TECHNICAL NOTE 1

DATE:	14 December 2023	CONFIDENTIALITY:	Confidential
SUBJECT:	Response to Active Travel England Comments		
PROJECT:	70094210 - Land at Buntingford West	AUTHOR:	Gideon G
CHECKED:	Mehmet A	APPROVED:	Mehmet A

This Technical Note (TN) has been prepared by WSP on behalf of Vistry Homes in response to Active Travel England (ATE) comments raised regarding the Buntingford West application (ref 3/23/1447/OUT), ATE ref ATE/23/00368/OUT on 07 November 2023.

Buntingford West – Peasmead Ownership Constraints

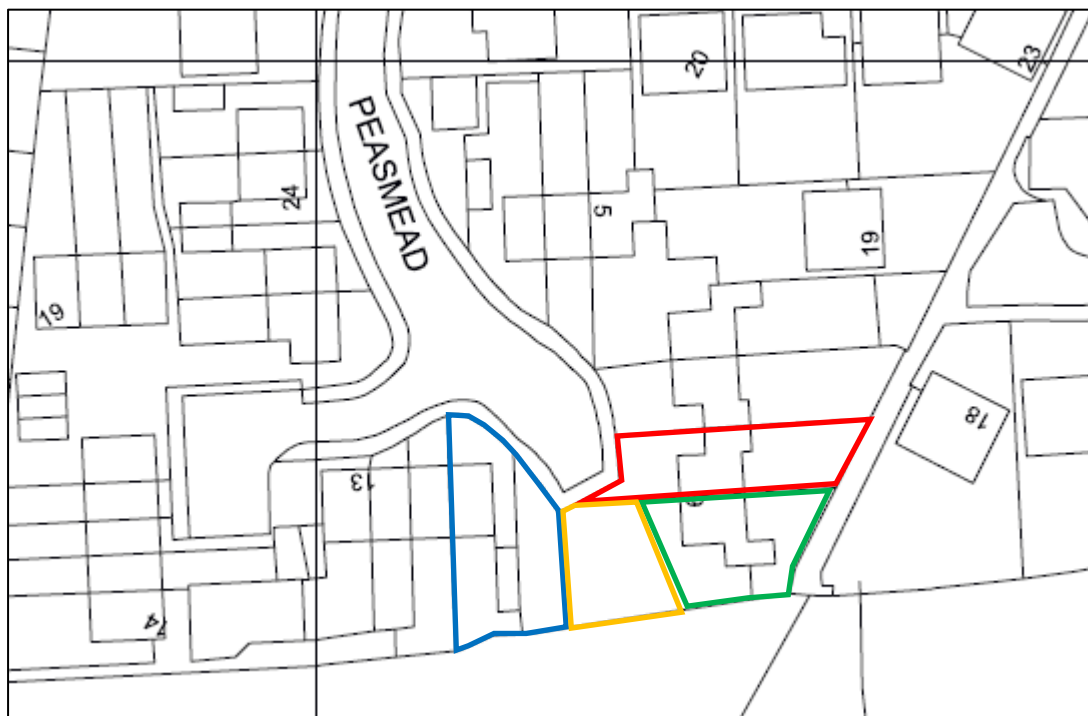
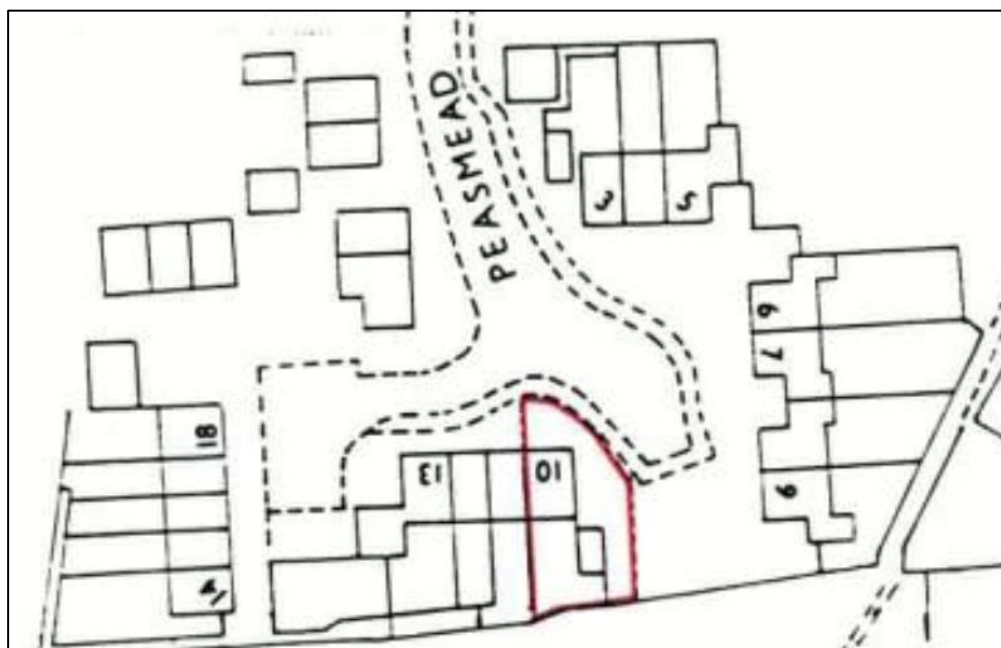
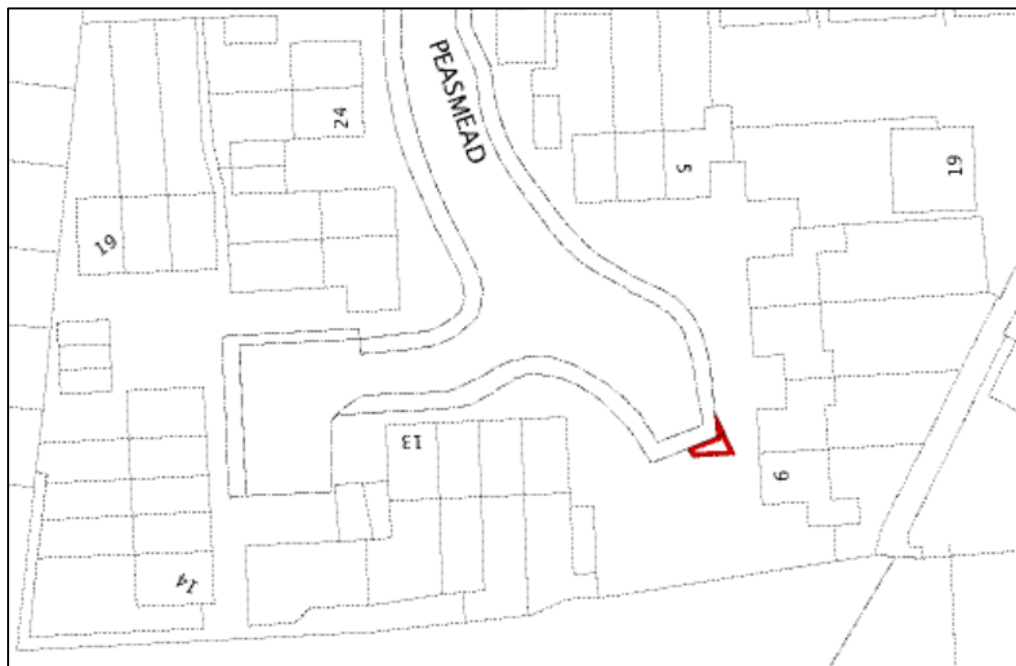
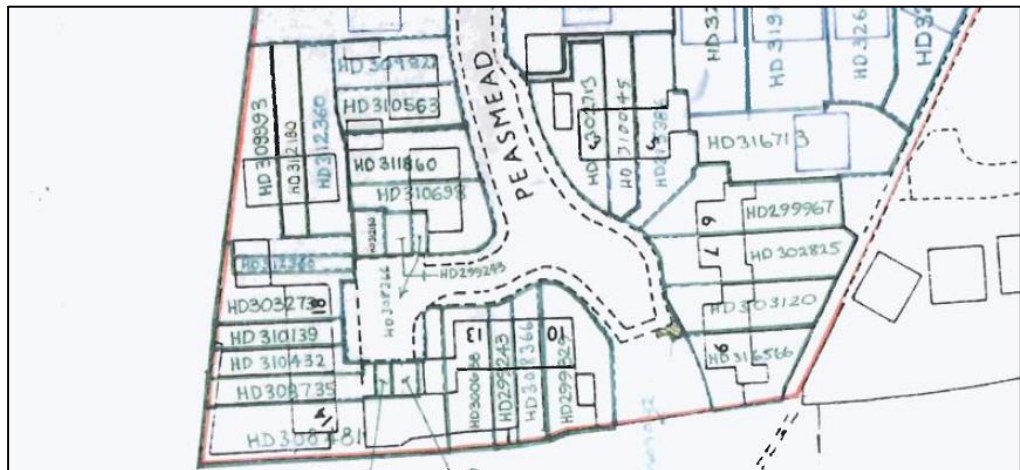
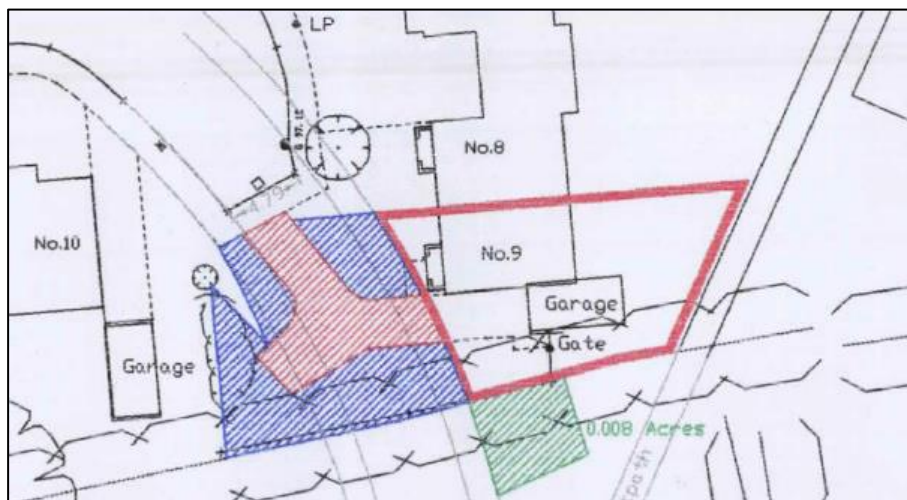
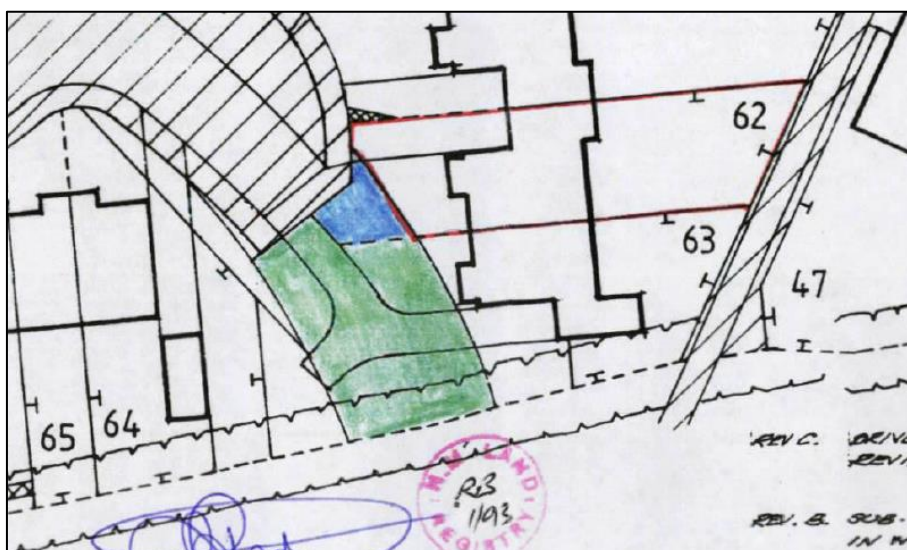
The applicant should demonstrate what exactly what treatment is to be provided at the access points with the public right of ways and at Peasmead where it is noted there is limited land available. ATE would like to understand what work has been undertaken to try and acquire land to provide more than one walking and cycling access that faces towards the village. This is especially important to the north of the site where direct connections to schools and the village centre are important and to the south to provide direct connections to the employment centre.

As previously mentioned, the connection via Peasmead was previously investigated but could not be pursued due to land ownership issues. The land between Peasmead and the Buntingford West development scheme is made up of four ownerships between No.8, No.9, No.10 and Vistry owns the proposed site edging this piece of land. The land provides a turning head and front garden to No.9 and access to No.8 and No 10. This part of Peasmead is an enclosed private cul-de-sac with driveways to the neighbouring houses and maintained gardens. Adding a pedestrian/cycle link across the existing residential drive and maintained gardens will be detrimental to this space.

That said, B26 provides an alternative to Peasmead albeit via a short 30m section where cyclist may have to dismount to connect with Knights Close.

HCC however advised at the November 2023 meeting that they are looking for a better access route and not necessarily an optimum route for both Monks Walk and Knights Close which are alternative routes to the north. It was discussed and agreed that minor improvements including vegetation clearing to improve
